CERTIFICATE OF APPROPRIATENESS

Property: 513 Euclid Street, Tract 13 and 14a, Block 22, Woodland Heights Subdivision. The property includes a historic 1,440 square foot, one-story wood frame single-family residence and a detached garage situated on a 5,000 square foot (50' x 100') interior lot.

Proposal: Alteration – Addition

SOUTH ELEVATION – FRONT FACING EUCLID STREET

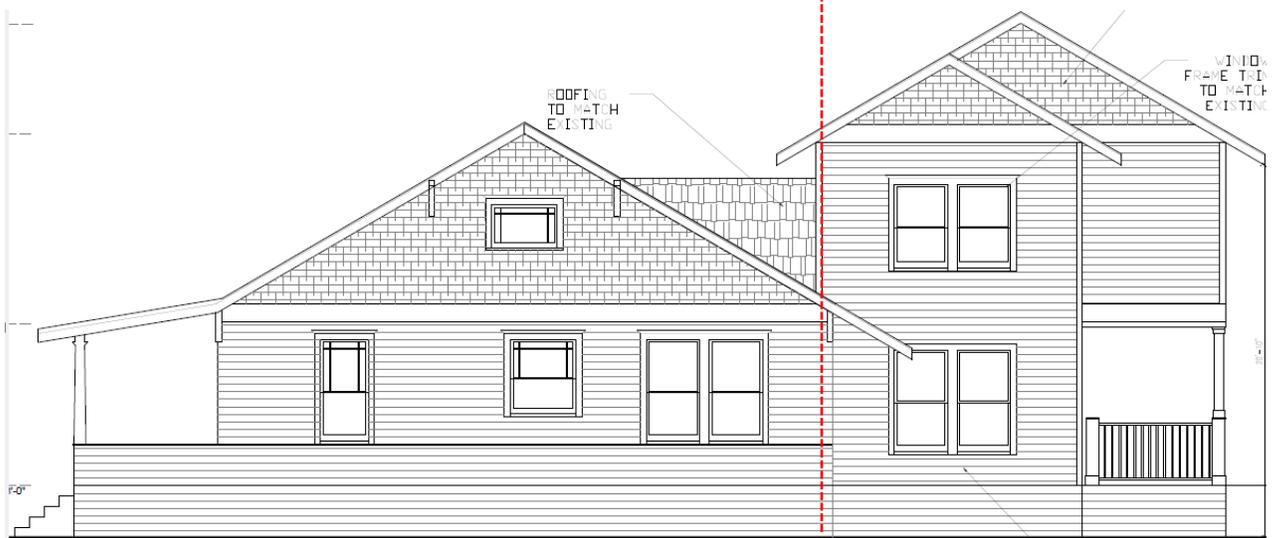
Front Elevation: The only portion of the addition visible from the front will be the roof structure of the proposed side gable roof. No changes are proposed for the front elevation of the existing structure.
(South)

EAST SIDE ELEVATION

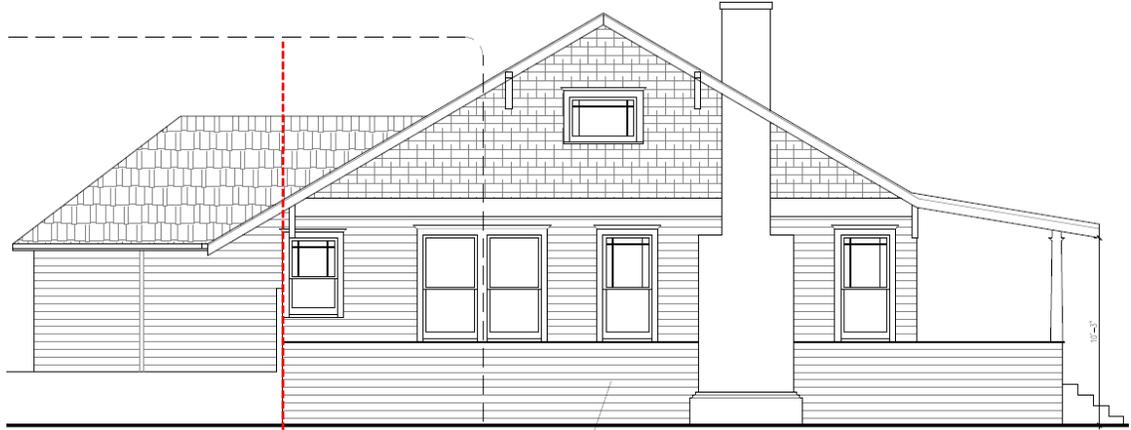
Side Elevation: The second story addition will begin 34' from the front wall of the original structure on top of a non-original rear addition. The addition will feature an 8' deep second story overhang supported by a pair of square columns. The addition will feature two east facing windows on the second floor.
(East)

WEST SIDE ELEVATION

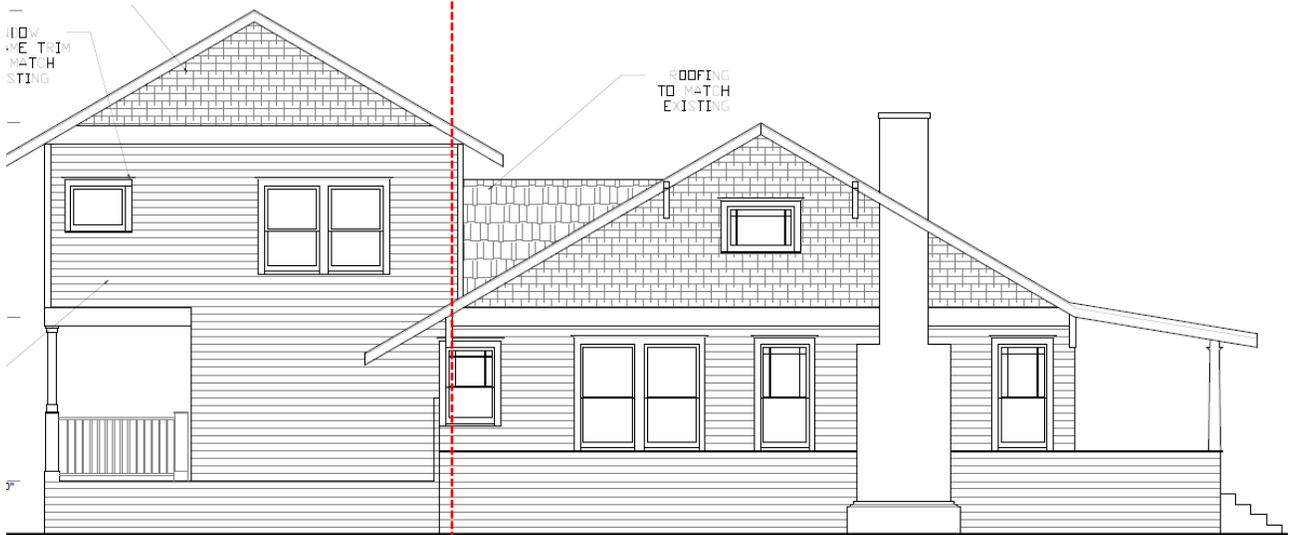
Side Elevation: The second story addition will begin 34' from the front wall of the original structure on top of a non-original rear addition. The addition will feature an 8' deep second story overhang supported by a pair of square columns. The addition will feature two west facing 1-over-1 windows and one casement window on the second floor.
(West)

NORTH (REAR) ELEVATION

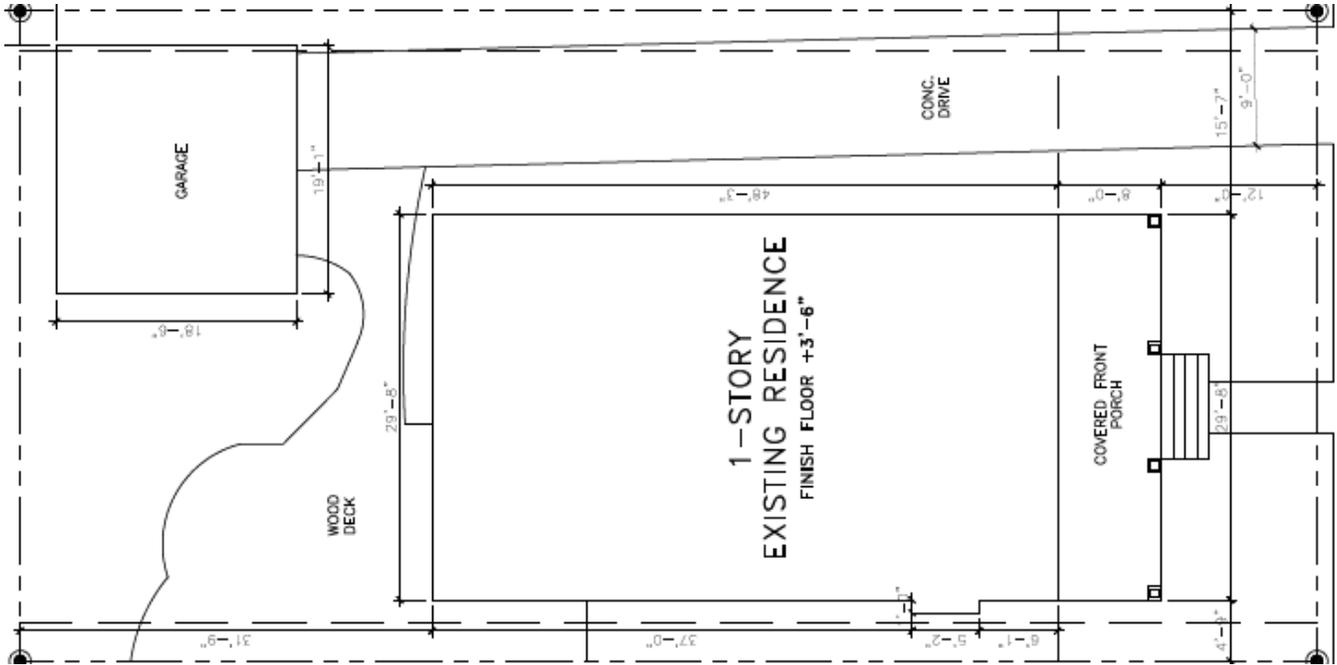
Rear Elevation: The rear elevation will not be visible from the street.
(North)

SITE PLAN
EXISTING

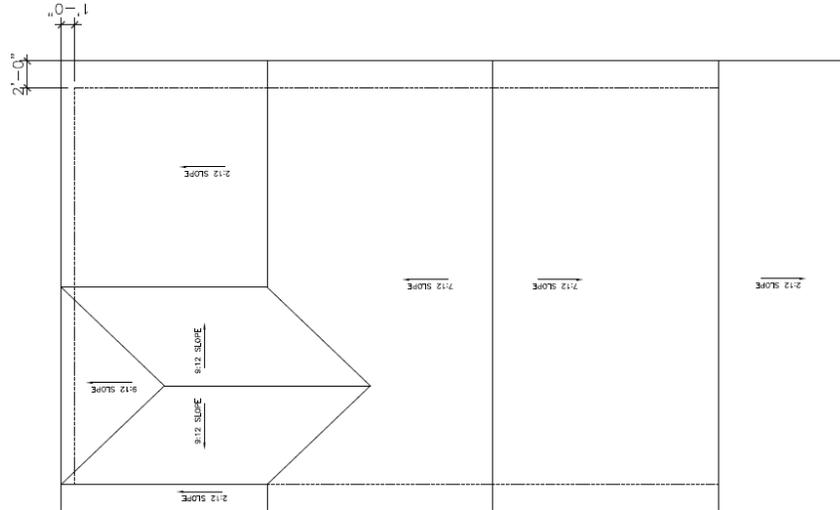
Setbacks: The addition will not alter the existing front or side setbacks.

ROOF PLAN
EXISTING

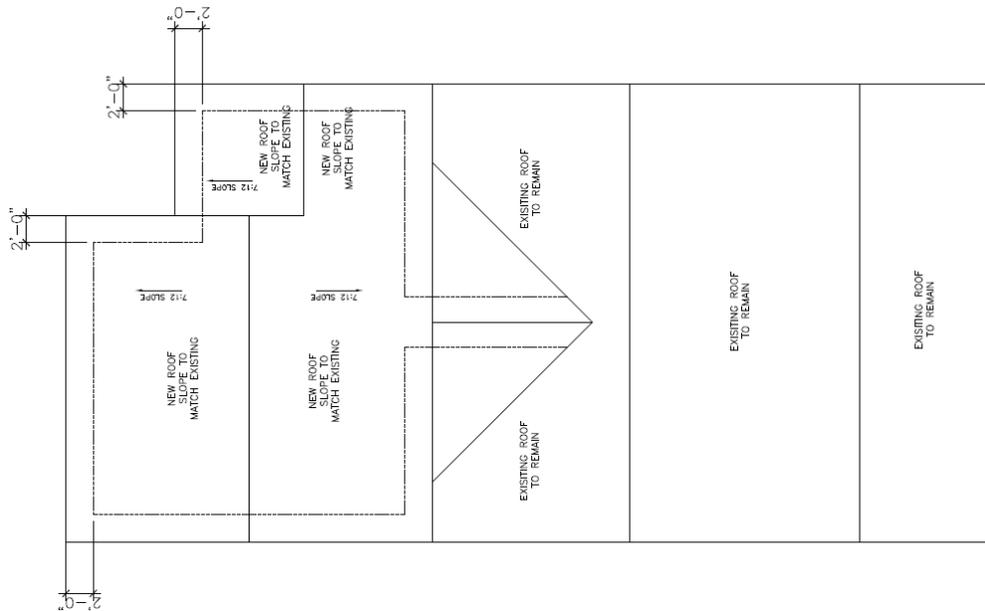
Roof: The existing residence features a side gable roof with a 7:12 pitch. The addition will feature two side gables and will feature a matching pitch. The addition will tie into the existing roof structure by way of a 7:12 pitched cricket installed in the center of the rear slope of the existing roof structure.
